Assessment Officer Report

PA2302487, 40 Mount View
Road, Boronia.

Officer Assessment Report
Development Approvals & Design

Figure 16: Location of Kiosk

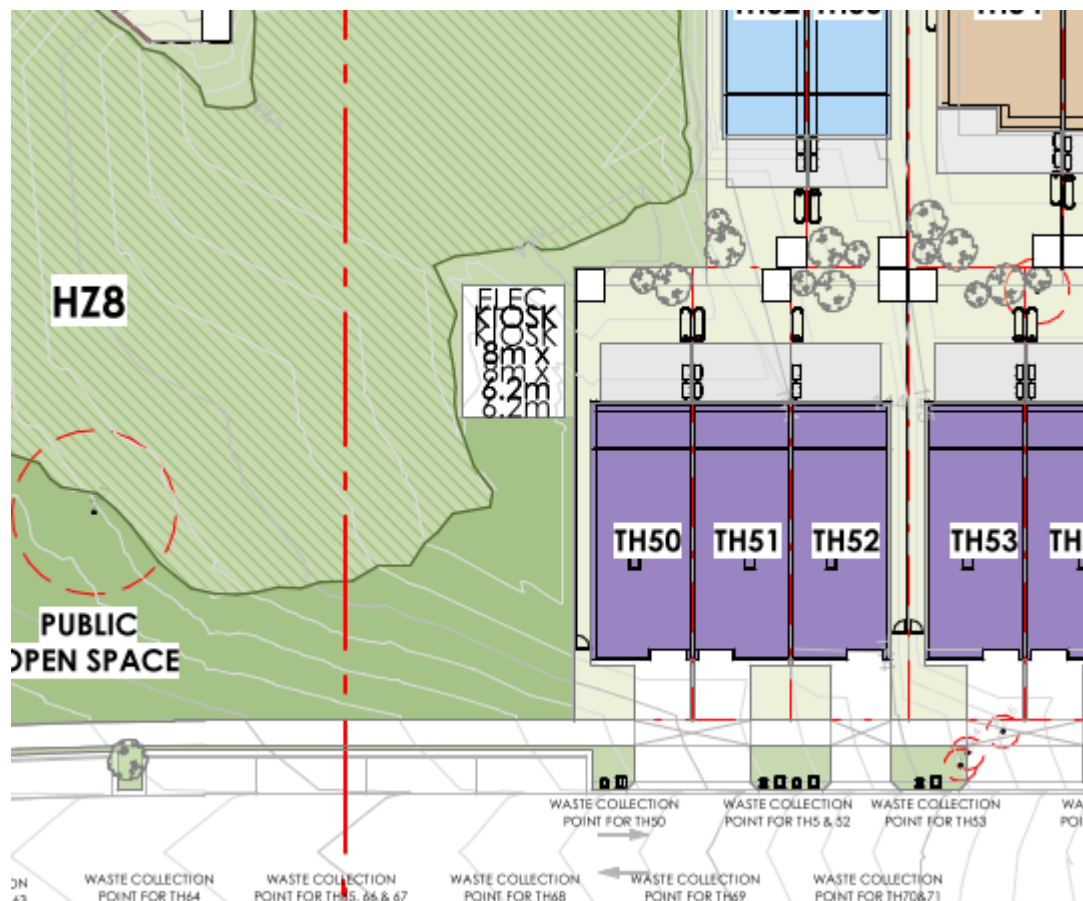
- In Council's previous response, we raised concern with the proposed 'kiosk' located between Dwelling TH50 and Habitat Zone HZ8, specifically that it was not clear what this was. The plans indicate that it is an Electrical Kiosk. The location of this kiosk is poor and does not appear to have paid consideration to how the kiosk will be accessed. The landscape plan proposes landscaping around the Kiosk and no arrangements for access to the Kiosk have been shown. The Kiosk needs to be relocated to a position that is easily accessible by a road or common property area and it should not rely on access through Public Open Space areas or Habitat Zones.

63. The plans show the location of the substation / electoral kiosk between Habitat Zone 8 and Townhouse 50 (TH50). DTP notes that anecdotal experience with development of similar scale suggests that these kiosks are required to be fully detached from any dwelling and sit as a 'standalone' module.

Figure 19: Location of Tree 194

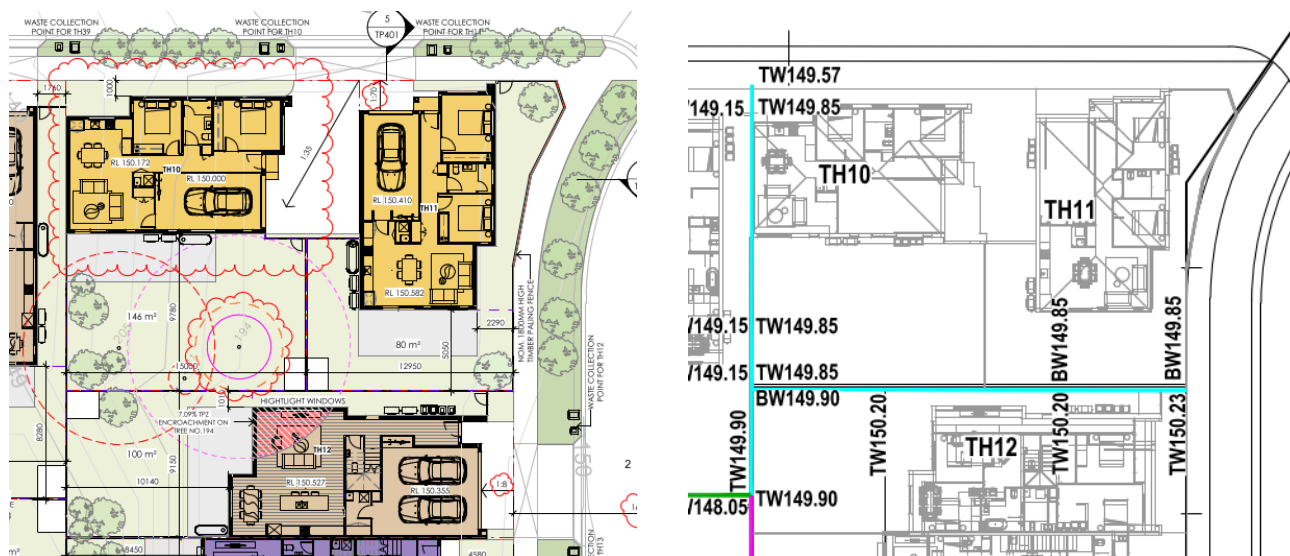
- The proposal has not been designed to ensure the long-term retention of Tree 194. The plans only indicate that Dwelling TH12 encroaches 10% into the tree's TPZ, however the complement of plans indicate that there will be site cut/fill, retaining walls, fences, sheds, water tanks and other works within the TPZ and SRZ of this tree. This is not supported, and the three surrounding dwellings need to be redesigned, including with the deletion of one dwelling to ensure that there is no more than 10% encroachment into Tree 194's TPZ and no works undertaken within the SRZ. Ideally the redesign should result in this tree being located within a reserve, road or common property area and not within the private open space of a dwelling.

73. The dwellings are located centrally within the development and are provided access via a new council road or via private access road.
74. All dwellings are provided with single or double garages, meeting the statutory parking requirements under Clause 52.06.
75. Dwellings TH10, TH11 and TH12 have SPOS areas within the TPZ of Tree 194 which is a protected tree on the site and is required to be protected and retained. Works also include proposed cut and fill up to 1m within the TPZ of this tree according to the provided cut and fill drawings.

- Reconfigure of Dwelling 10-12 to delete a dwelling and ensure that no works occur within the SRZ of Tree 194 and no more than 10% encroachment into the TPZ by buildings and works, including site cut/fill and all buildings or the layout of the development modified to locate the tree within a reserve, roadway or common property;
- All dwellings are to be provided with a Private open space area consisting of: An area of 80 square metres with one part of the private open space to consist of secluded private open space at the side or rear of the dwelling or residential building with minimum area of 60 square metres with a minimum dimension of 5 metres of secluded private open space with convenient access from a living room;

Figure 20: TPZ of Tree 194 affected by cut/fill

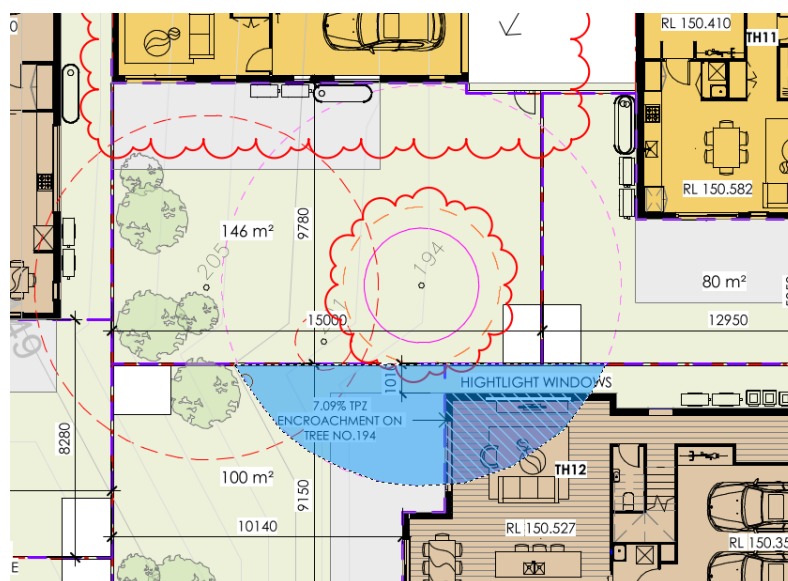
76. The extent of encroachment to this protected tree through either the extent of cut, fill and retaining walls is 25% is greater than the allowable 10% under Australian Standards and is an unacceptable outcome for the health of this tree.

Figure 21: TH31 Ground Floor layout

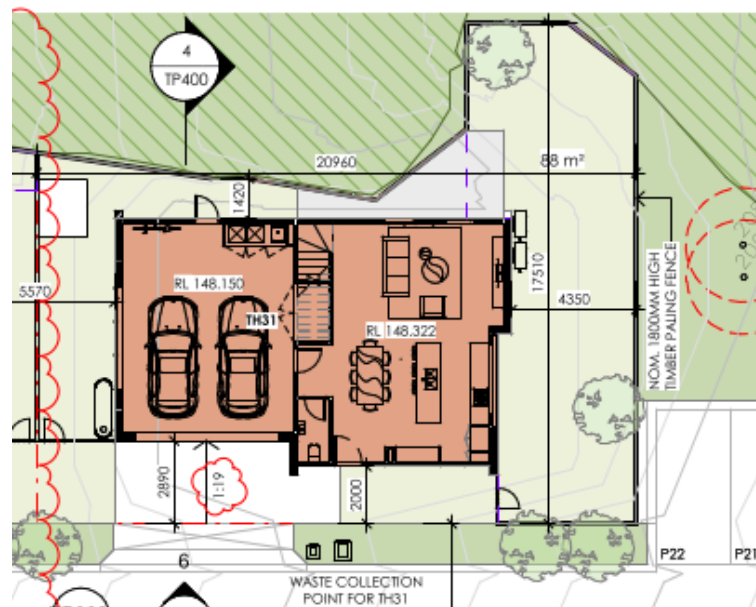
77. Dwellings adjoining HZ9 (TH30 & TH31) will be subject to a condition to have permeable fencing to allow views into the adjacent habitat zones to provide a sense of surveillance, the remainder of the dwellings located within this grouping do not have any direct interface with the habitat zones and can be provided with traditional fencing arrangements.
78. Dwelling TH31 SPOS is compromised due to the location of the adjoining habitat zone at the rear of the dwelling. The irregular shape of the lot will require the ground floor to be redesigned to allow better access to the SPOS area associated with this dwelling. The current design has the door opening directly onto the rear fence and will be conditioned to be relocated to the southern wall where the SPOS area is located. The redesign of the ground floor layout for TH31 will be a condition on any permit issued.

79. In addition, it will be required for the floor plan layouts for Townhouse Type 05 be updated to show all windows on the upper level as per the elevations and the location of the laundry to be relocated out of the garage into the storage space and be accessible internally via the main living room of the dwelling. The garage meets the minimum dimensions require and does not provide enough space for the addition of a laundry cupboard and associated doors which will restrict parking and provides for a poor amenity outcome for future residents.

Figure 26: Plan TH61 – TH71 & TH92 – TH93

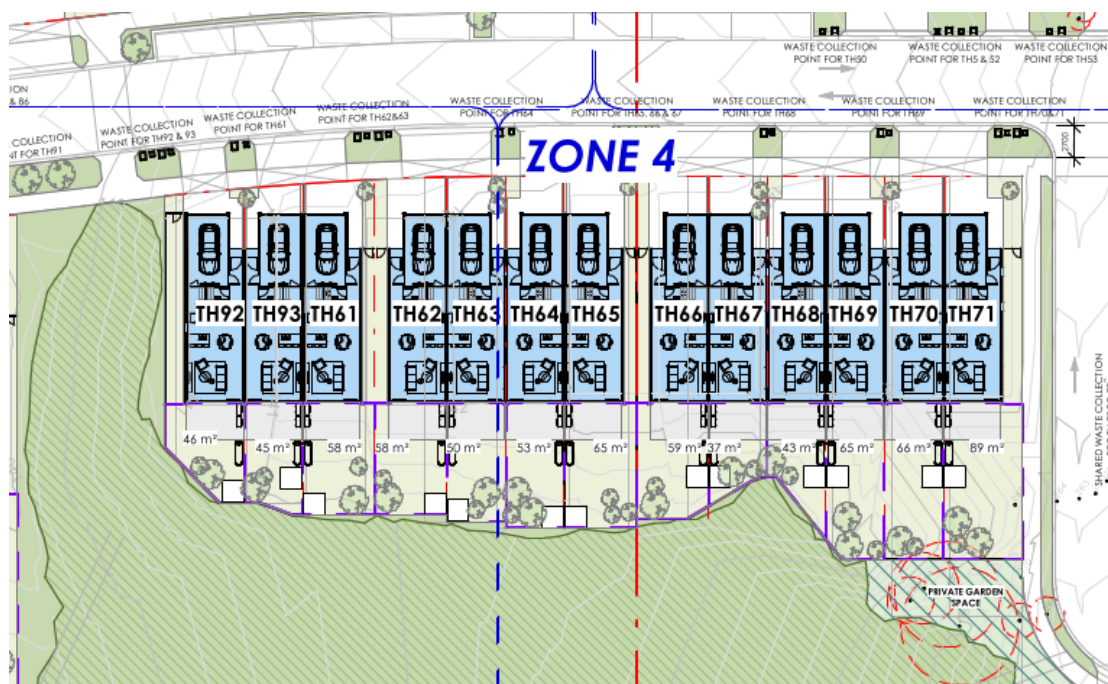
93. The following trees TPZ's – Trees 369, 371, 390, 398 and 400 will be conditioned to be shown on the site plans and cut and fill plans to ensure no encroachment greater than 10% allowable under Australian Standards. These

Figure 27: Rear (west) elevation TH61 – TH71 & TH92 – TH93

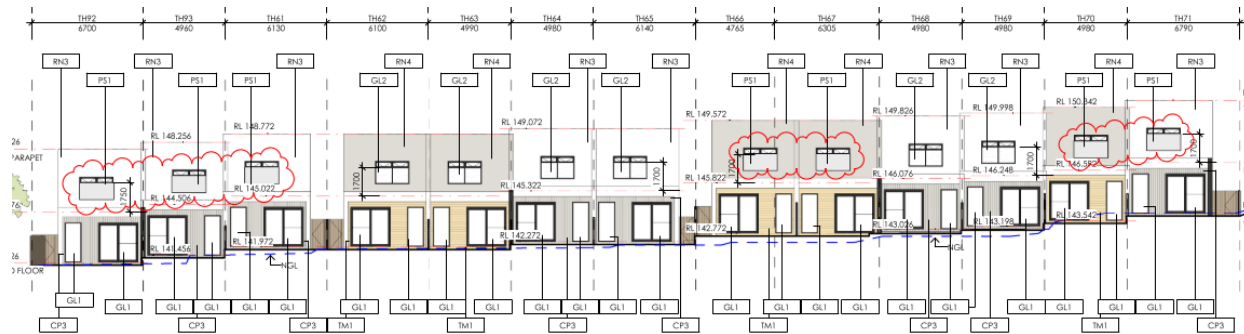
94. The upper-level bedrooms overlooking the Habitat Zone are shown with obscure glazing, however the planning scheme has changed, and these windows will be conditioned to contain clear glazing to provide passive surveillance of the surrounding habitat zone and meet the overlooking requirements.
95. The narrow frontage of these blocks results in a front elevation for these dwellings consisting of garage doors and the front doors. There is no surveillance opportunities from the ground level to the street and therefore the sense of address for these dwellings is compromised.
96. It will be conditioned that the front doors are provided with some glass panels to allow residents visibility of their porch and the broader frontage. The changes to the doors will provide a sense of address and safety for residents.

Figure 29: Front (east) elevation showing variation between driveways

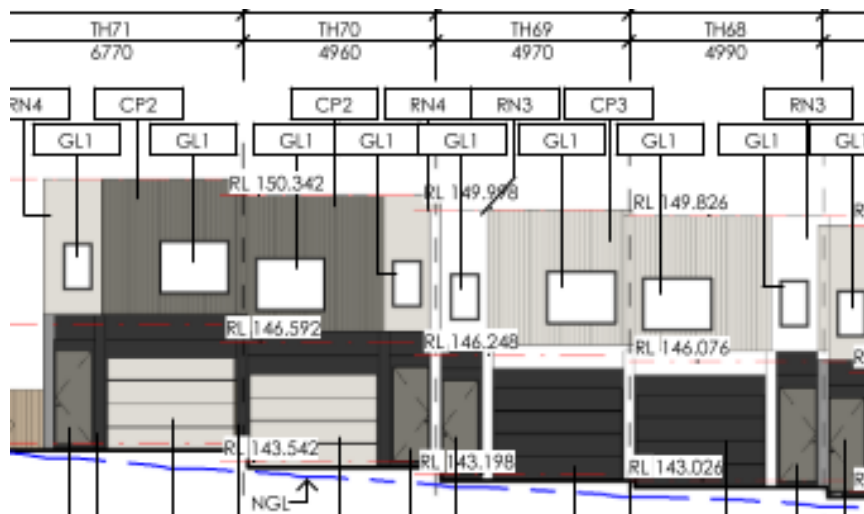
97. Conditions will be included to ensure that driveways have limited difference in level. This will include TH70 & TH71, TH68 & TH 69 and TH61 & TH93. The variations in heights between adjacent driveways is both impractical and creates unsafe opportunities for vehicle movements.

Figure 39: Plan TH120 -TH122 & TH131 – TH135

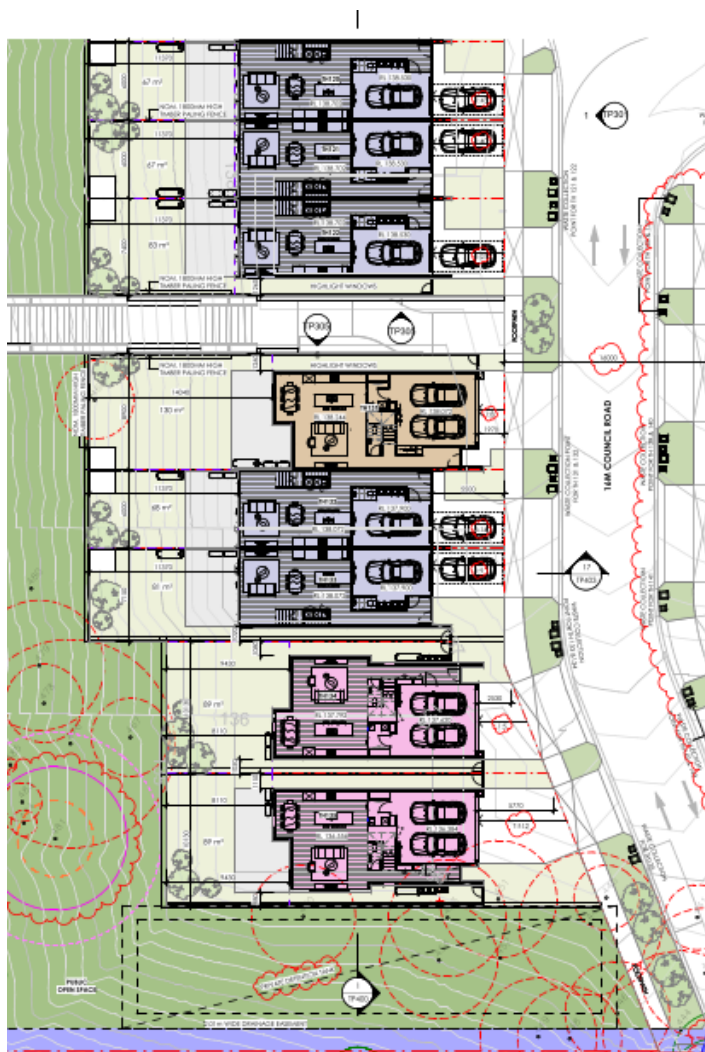
115. Tree 481, specified as a protected scattered tree will be located within the SPOS of TH135, consideration will be required to the location and extent of retaining walls within the rear yard of this dwelling.

Figure 45: West Elevation TH144

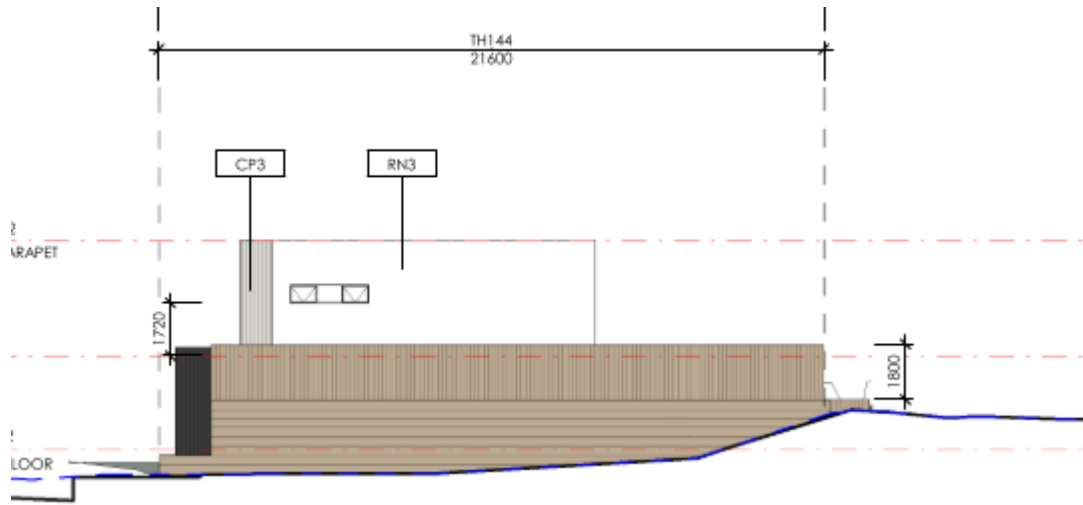
121. The dwelling groups are separated by extensive site cut between each module resulting in some dwellings having compromised rear yards with extensive retaining walls and fencing and reduced sunlight to SPOS areas.
122. Dwelling TH144 provides a poor interface for entry into the development from Monroe Street, providing only one highlight window to the western elevation and limited visual interest.

123. A condition on the permit to modify the window to enable views to the west from the dwelling to the open space located adjacent to the dwelling.
